County File No. PPR2048

DRAWN BY: O.E. WATTS DATE: 12-4-20 DWG. NO.: 20-5449-04 SURVEYED BY: DEV. E.S.V. 4-29-20 12-4-20	APPROVED BY: PROJ. NO.: DWG.:	REVISIONS 7-6-21 REVISED PER COUNTY REVIEW DEW	OLIVER E. WATTS CONSULTING ENGINEER COLORADO SPRINGS	PROJECT 16965 LINDBERGH ROAD N1/2, N1/2, NW1/4, SE1/4, SEC. 22, T.11S., R.67W. EL PASO COUNTY	SHEET NAME <b>GRADING AND EROSION CONTROL PLAN</b>	SHEET NO. OF 2
---	-------------------------------------	--	--	--	---	-------------------

DRAWN BY: D.E. WATTS DATE: 12-4-20 DWG. NO.: 20-5449-05 SURVEYED BY: DEV, ESV, 4-29-20	APPROVED BY:	REVISIONS	PROJECT 16965 LINDBERGH ROAD N1/2, N1/2, NW1/4, SE1/4, SEC. 22, T.11S., R.67W. EL PASO COUNTY	SHT. NAME <b>GRADING AND EROSION CONTROL PLAN</b>	SHT. NO. 2 OF 2
	PROJ. NO.

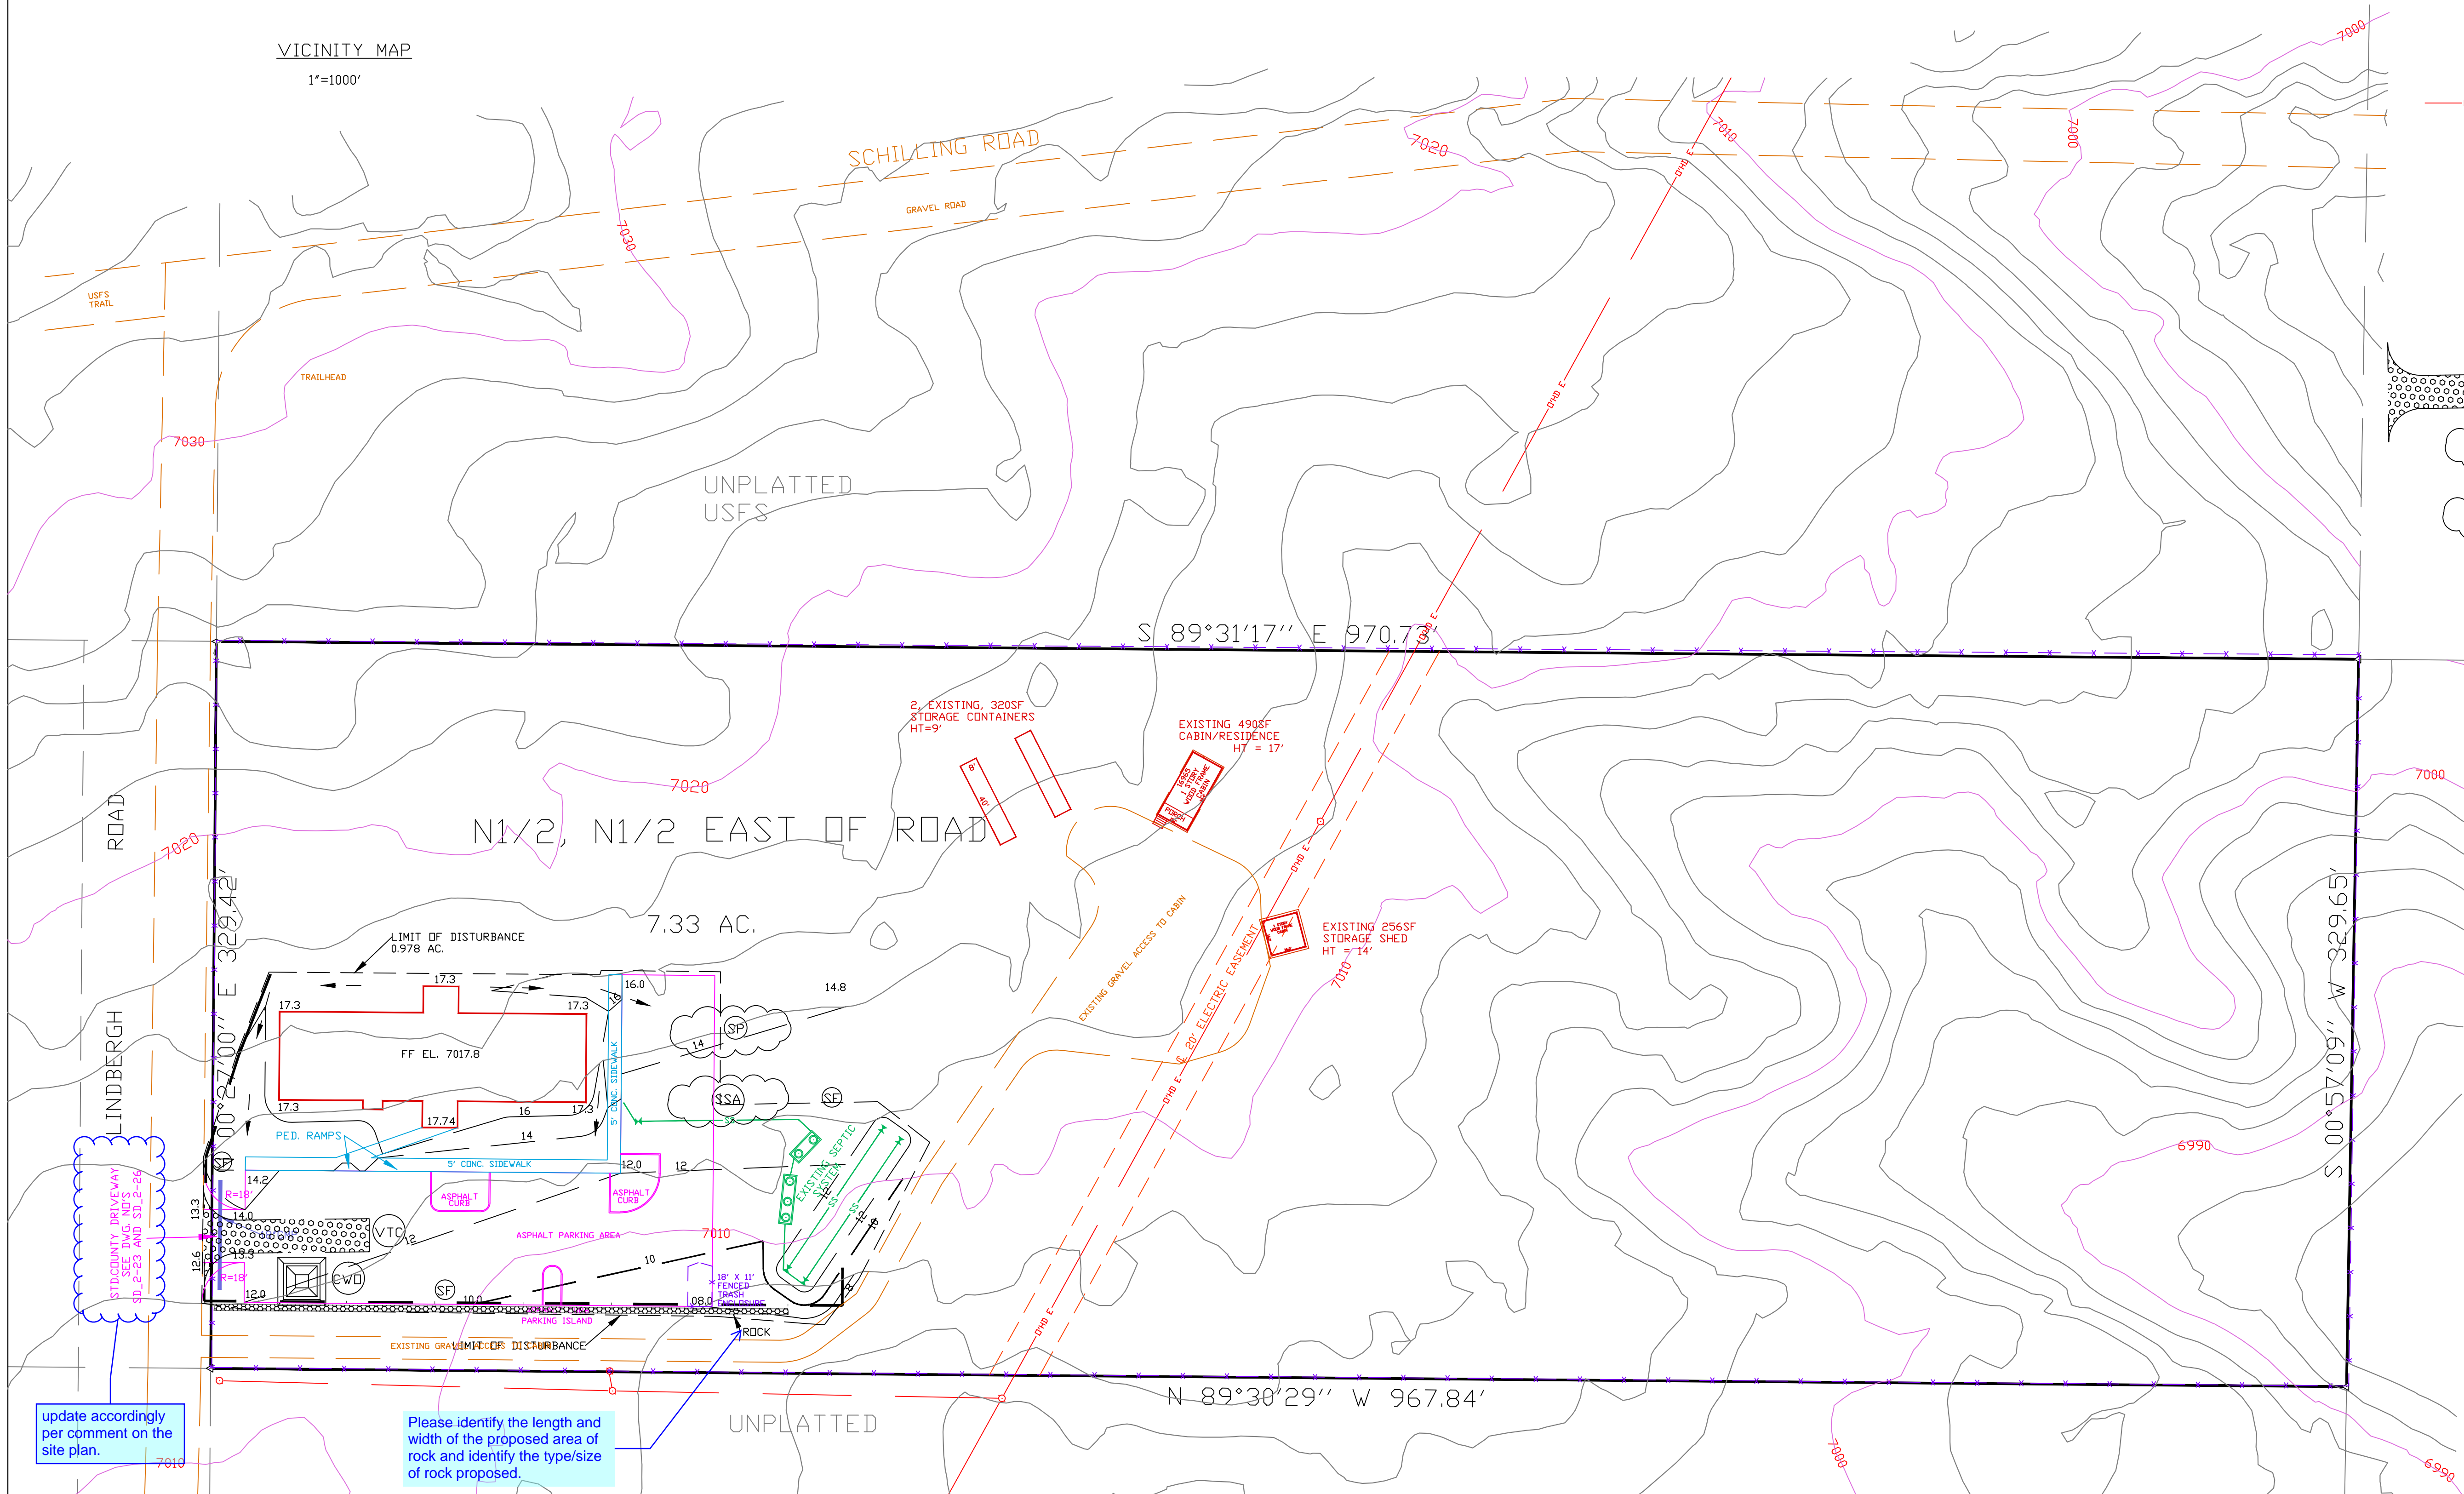
update accordingly per comment on the site plan.

Please identify the length and width of the proposed area of rock and identify the type/size of rock proposed.
